**RFI 098
Pebble Project EIS**

Title/Subject:	TSF Options, Mine Area
Requestor:	AECOM
Date Transmitted:	10/16/2018
Recipient:	Pebble Limited Partnership (PLP)
Response Requested by:	10/22/2018
Rationale:	The PLP response for RFI 069 presented 26 potential TSF locations that were considered near the mine area. Details on feasibility and environmental considerations for these locations are necessary for alternatives screening purposes and for the USACE to evaluate the Least Environmentally Damaging Practicable Alternative (LEPDA).
Describe the Information Requested and Level of Detail:	<p>Please provide an evaluation of each mine area TSF location that was considered and explain why the NFK West and NFK East locations were ultimately selected. Include:</p> <ul style="list-style-type: none"> • Feasibility (technology, economics, logistics, common sense) • Availability (both now and ten years ago during project planning) • Environmental impacts (wetlands/Waters of the US, miles of streams, habitat, fill, dam safety, etc.)

The question presented in RFI 098 on TSF options in the mine area is addressed below:

TSF OPTION 25

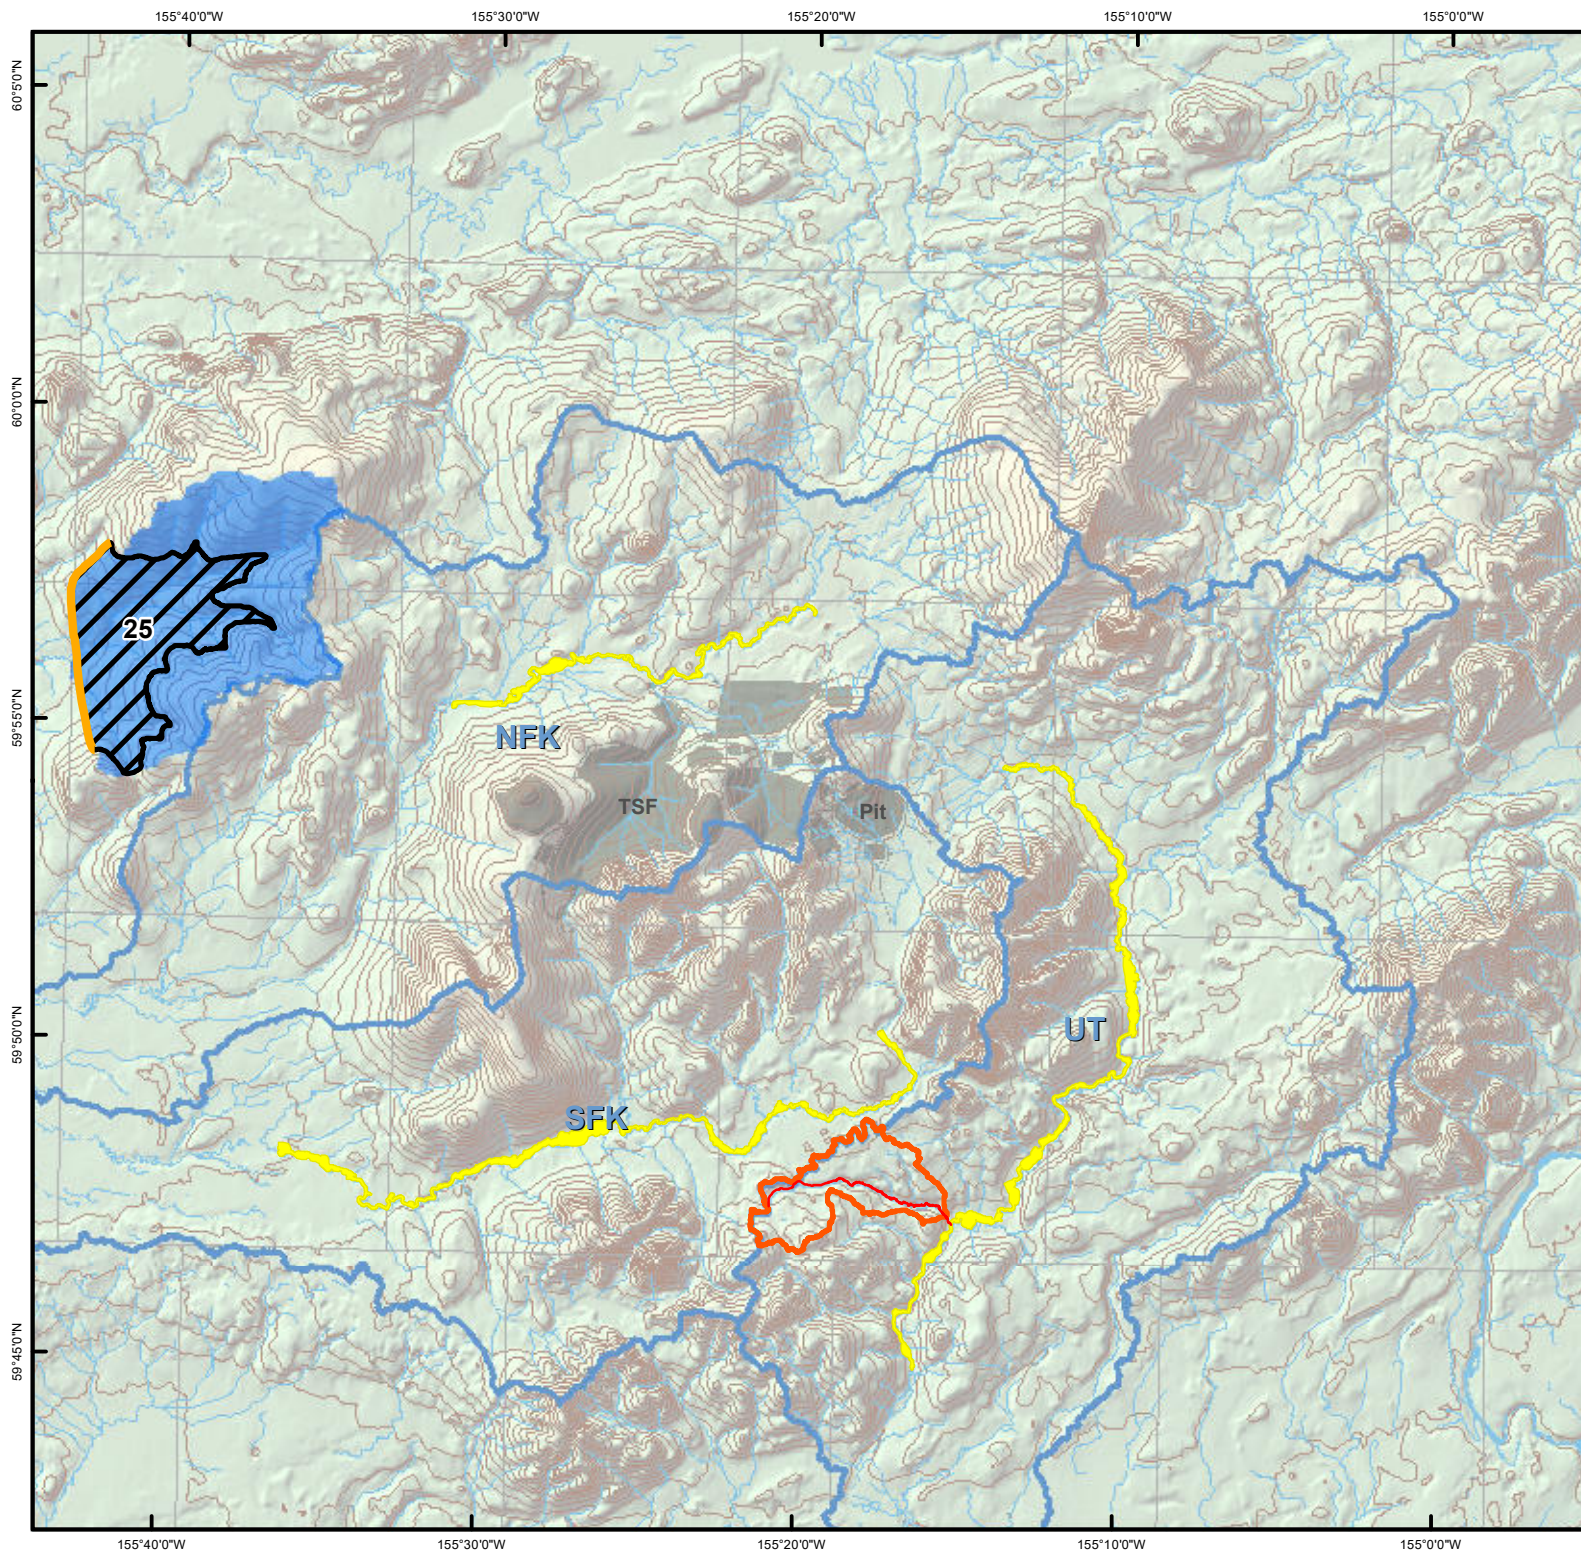
Option 25

USACE has requested that PLP confirm the wetlands acreage associated with TSF Option 25 as the percentage of wetlands in the footprint for this option appears anomalously low in comparison to the proposed project. As noted in RFI 98, PLP has not acquired detailed wetlands mapping for the area in TSF Option 25 so the National Wetlands Inventory (NWI) data was used to estimate wetlands.

- Extends direct impacts into the lower portion of the Kaktuli drainage.
- No PLP wetlands and fisheries data are available for this option. NWI wetlands data has been utilized for the spreadsheet analysis.
- Mapped wetlands impacts are lower, but stream related impacts are higher due to the size of the drainage upstream of the embankment.
- The facility as reported is larger than required to store 1250 million tons of tailings, but this could be adjusted by dropping the embankment height. Direct fill impacts would be reduced but overall drainage basin impacts would be unchanged.
- Tailings would need to be pumped for 25 miles and the overall project footprint would be significantly larger and more dispersed with this option.

Based on this analysis it is reasonable to assume that an estimate of 2820 wet acres in the Option 25 footprint is more representative of actual wet acres than the 1193 acres mapped in the NWI.

TSF OPTION 26

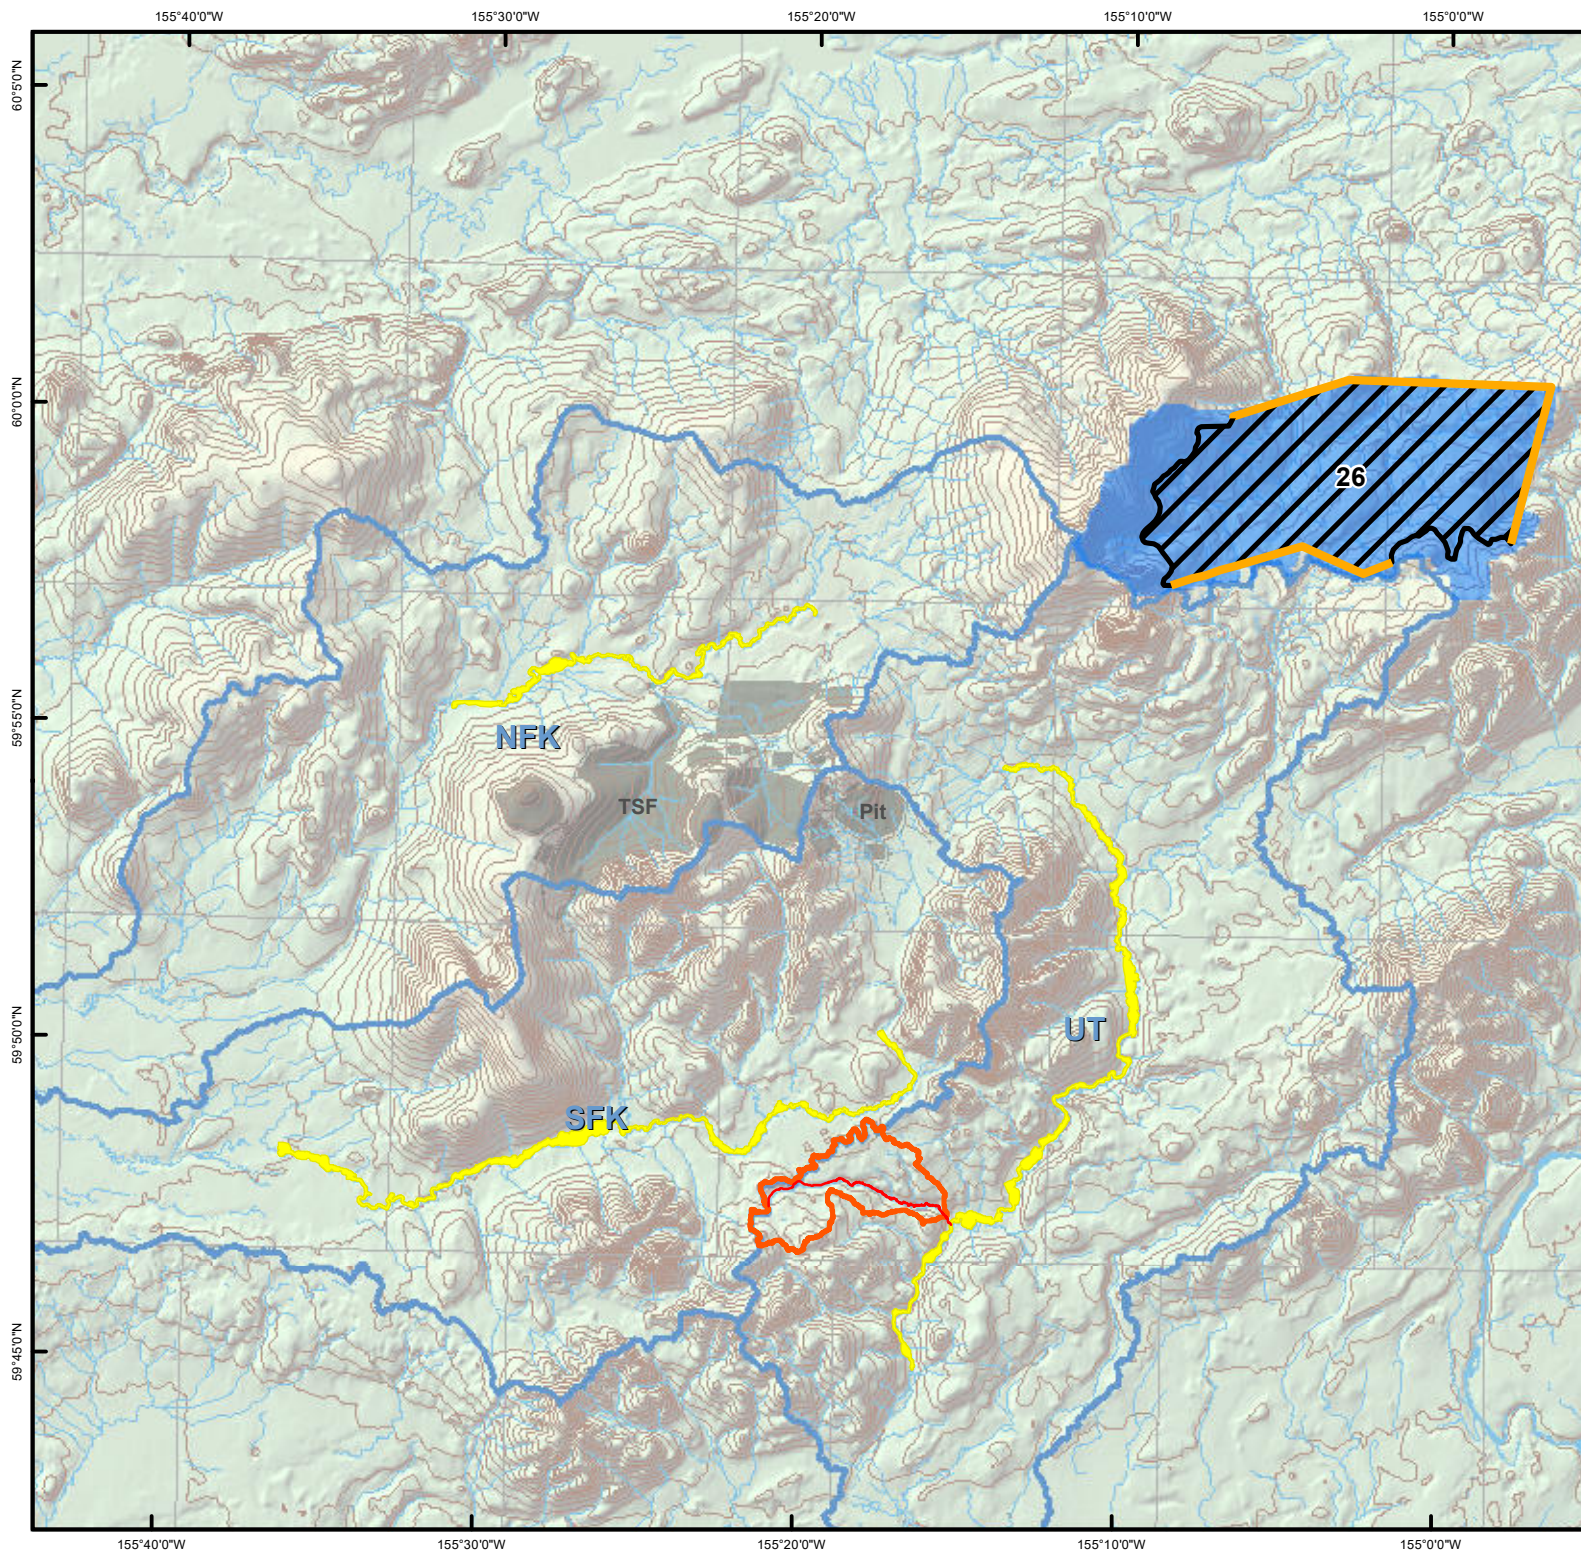
Option 26

- Extends direct impacts into the Lake Clark drainage.
- No PLP wetlands and fisheries data are available for this option. NWI wetlands data has been utilized for the spreadsheet analysis.
- Mapped impacts are higher in all categories.
- The facility as reported is larger than required to store 1250 million tons of tailings, but this could be adjusted by dropping the embankment height, which would not significantly change the reported impacts due to the low storage efficiency for smaller volumes of tails.
- Tailings would need to be pumped for 20 miles and the overall project footprint would be significantly larger and more dispersed with this option.

Proposed TSF (NWI & Mapped) Option 25 (NWI)

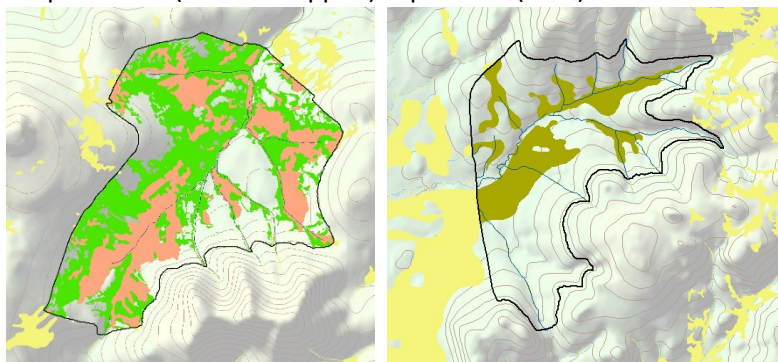
As noted, the acres of wetlands appear anomalously low. To better quantify the impacts for Option 25, PLP investigated the ratio of NWI to mapped wetlands observed in the proposed bulk TSF location. For the proposed bulk TSF the numbers (acres) are as follows:

Estimated Wetlands If Mapped – 2820
